18 January 1945

**NORTH AMERICAN—MODIFICATION OF COOLANT EXPANSION TANK  
ASSEMBLY—P-51B, P-51C, AND P-51D**

**RESTRICTED**  
T. O. No. 01-40J-23

**Figure 1 - Remove Front and Intermediate Formers to Engine Mount and Disconnect Header Tank Cross-flow Line**

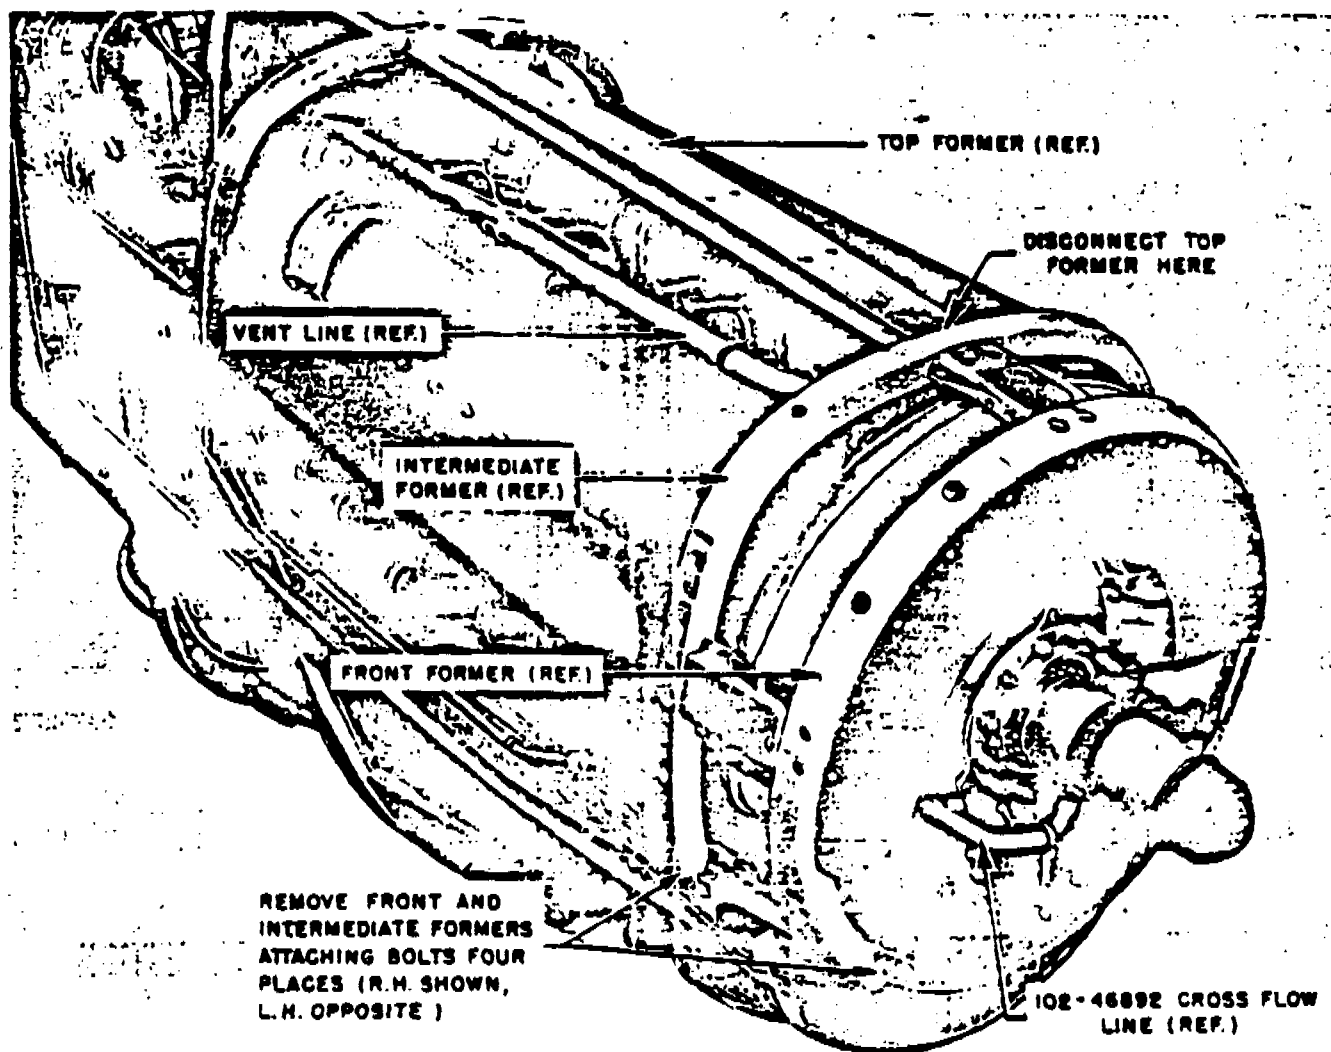
- a. Remove the top and side engine cowling.
- b. Remove the four bolts (two on each side), which secure the front and the intermediate formers, part Nos. 102-310210 and 102-310254, respectively to the engine mount. (See figure 1.)
- c. Disconnect the forward end of the top former (longitudinal) part No. 102-31056, from the intermediate former, part No. 102-310254.
- d. Remove the front and intermediate formers from the airplane as a unit. The armor plate will be removed with the unit.

(1) Disconnect the expansion tank cross-line, part No. 102-46892, from the expansion tank (See figure 1.)

Figure 2 - Indicated Cutting Plane on Tank Outlet Fitting,  
Part No. 102-46094

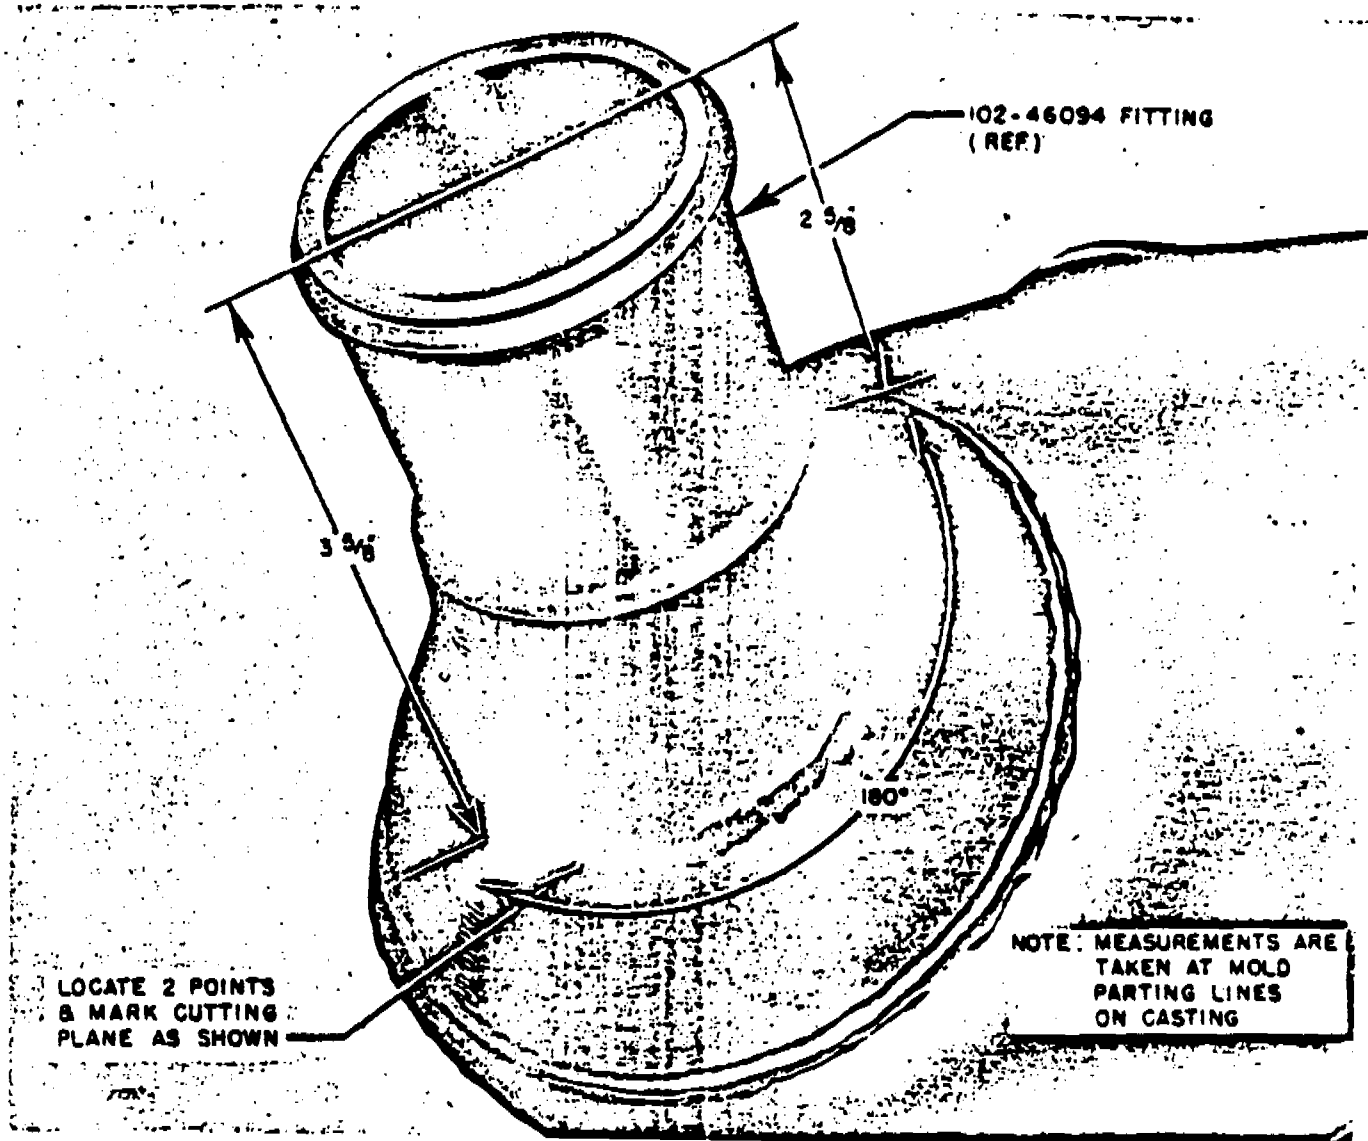
(4) Mark a cutting plane on each of the tank outlet fittings, part No. 102-46094. (See figure 2.)

Figure 3 - View After Cutting Showing Three Supporting Lugs Before Rework - Left-hand Outlet Shown

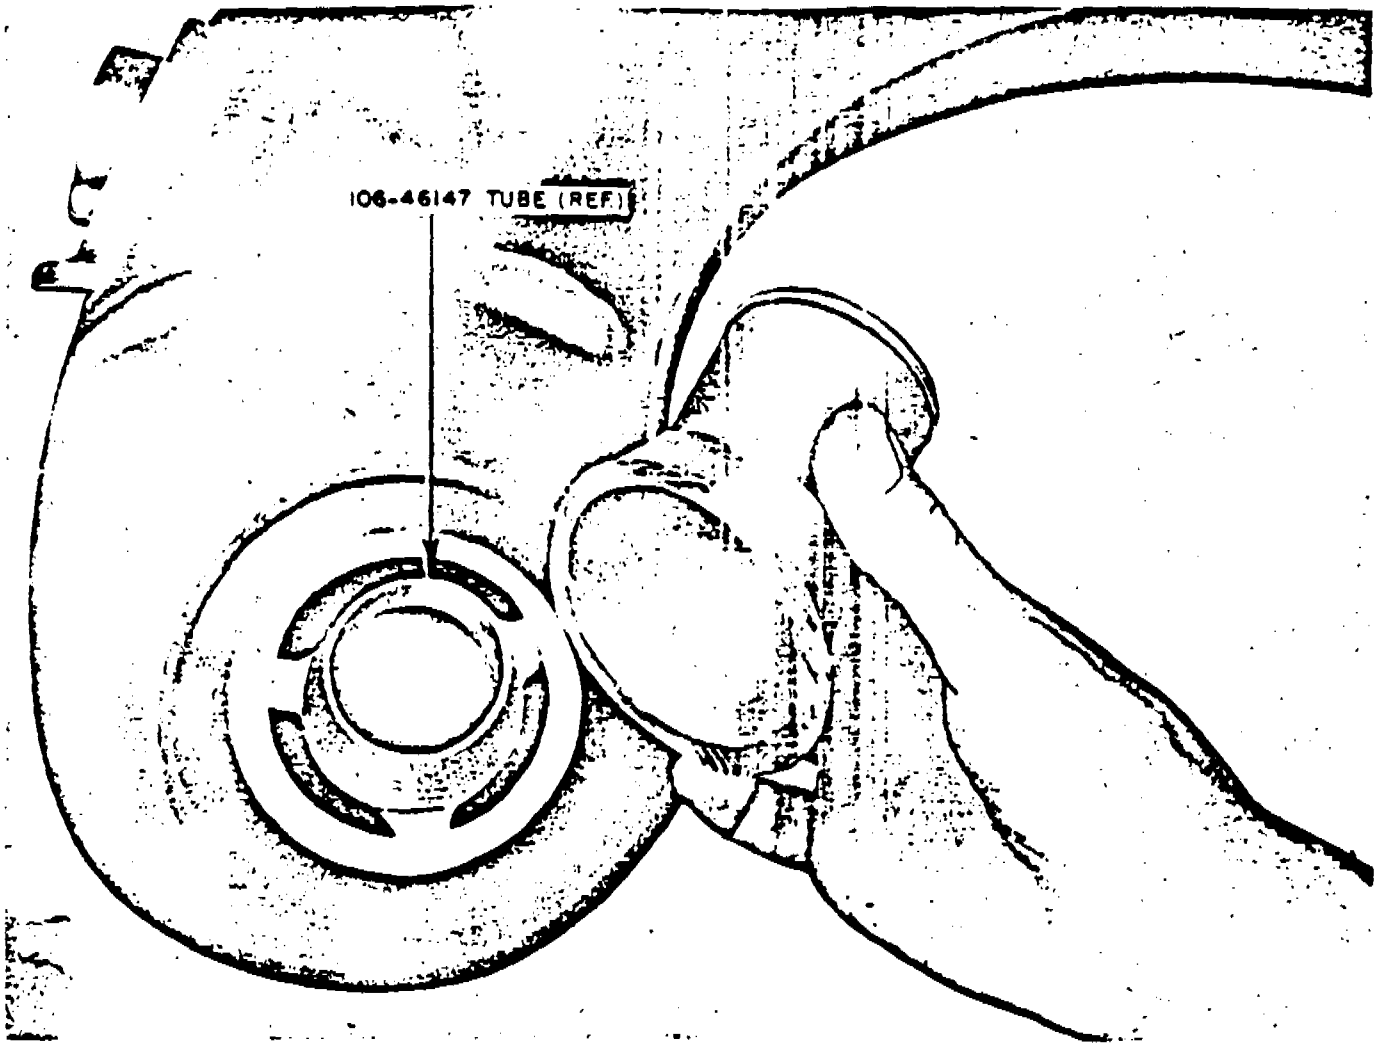
(5) Cut the fittings into two parts along the line marked, thus gaining access to the tube support lugs. (See figure 3.)

**CAUTION** Cut around the fittings, taking care not to damage the tube, part No. 106-46147, which extends beyond the cutting plane.

Figure 4 - Building Up the Lug by Additional Weld

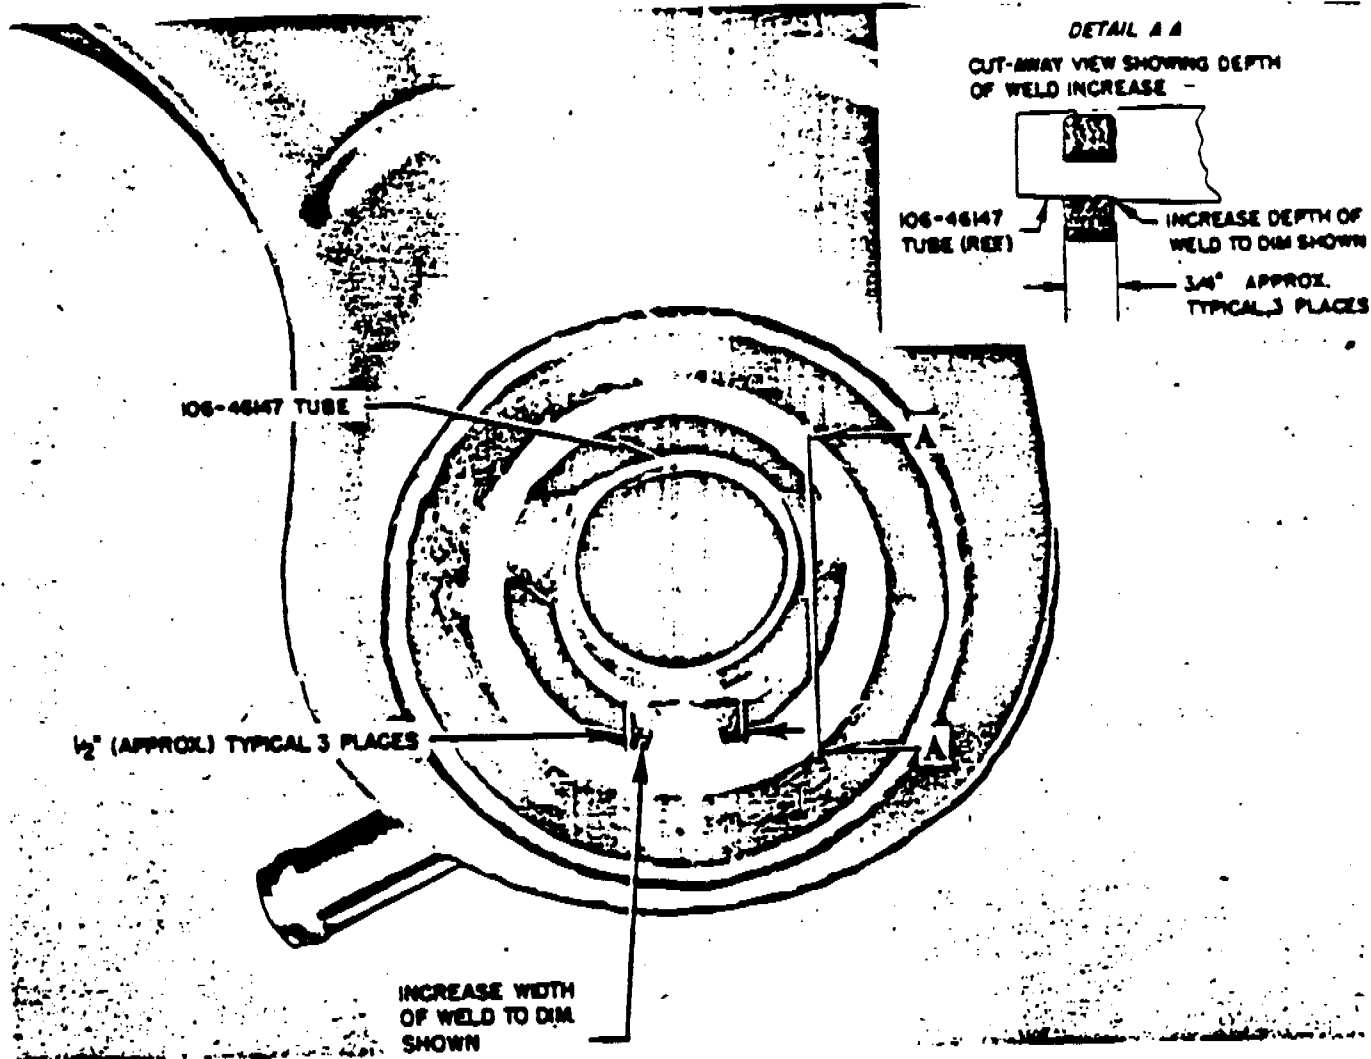
(6) With a file, clean the anodic finish from the existing weld and the areas adjacent to the three lugs.

(7) Build the lugs up with additional weld. (See figure 4.)

Figure 6  
View  
Showing  
Fitting  
After Re-  
work

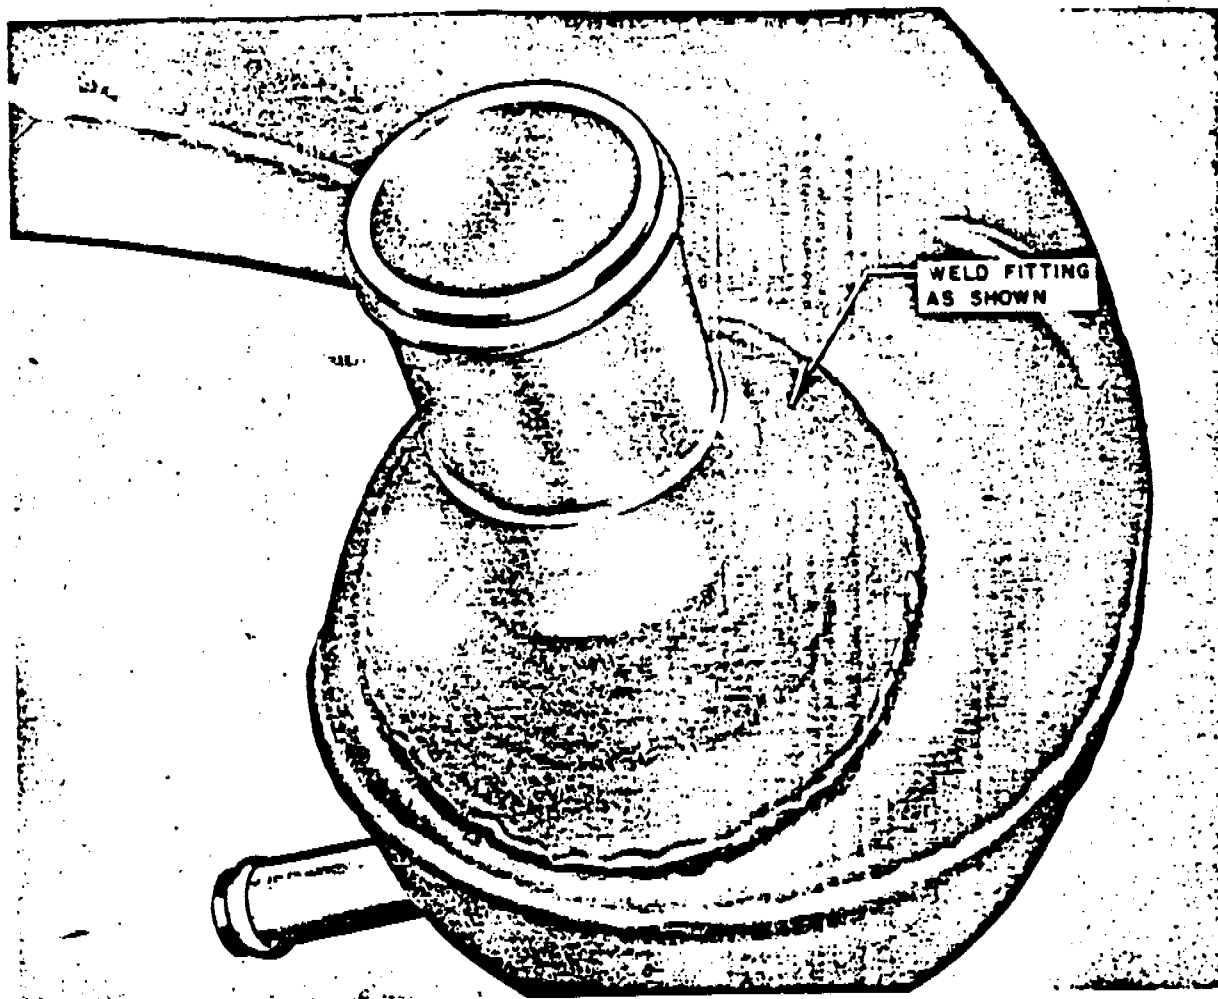
(8) Weld the fittings together again. (See figure 5.)

(9) Pressure test tank at 50 psi.
